FREDERICK COUNTY PLANNING COMMISSION July 10, 2019

TITLE: Coffman Recycling Service

FILE NUMBER: SP-78-04, AP-19445 (FRO-19446 & APFO-

REQUEST: Site Development Plan Approval

Exhibit 1-Coffman Recycling Site Plan Rendering

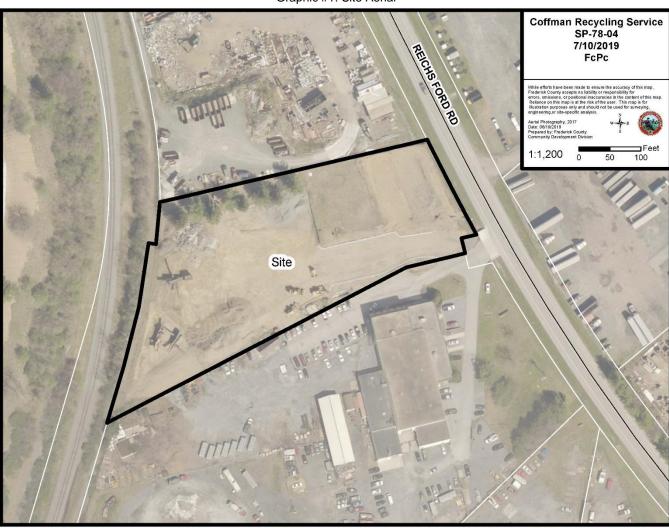
- 5. Lighting §1-19-6.500: The proposed site plan includes residential style building mounted lighting at the entrance to the 40' trailer. The proposed lighting shall be cast down to prevent glare onto adjoining roads and properties in accordance with Zoning Ordinance Section 1-19-6.500. There will be no light trespass over 0.5-foot candles at the property line. No additional lighting is proposed at this time. Prior to final Site Development Plan signature approval, the Applicant shall verify that

the proposed residential style lighting is required security lighting and is therefore exempt, or will submit a photometric plan as provided in section 1-19-6.500 of the Zoning Ordinance.

- 1. Address all agency comments as the plan proceeds through to completion.
- 2. Prior to final Site Development Plan signature approval, the Applicant shall verify that the proposed residential style lighting is required security lighting and is therefore exempt from §1-19-6.500, or will submit a photometric plan in compliance with section 1-19-6.500 of the Zoning Ordinance.
- 3. Revise the site plans to reflect the existing conditions including landscaping that is existing versus what is being proposed.
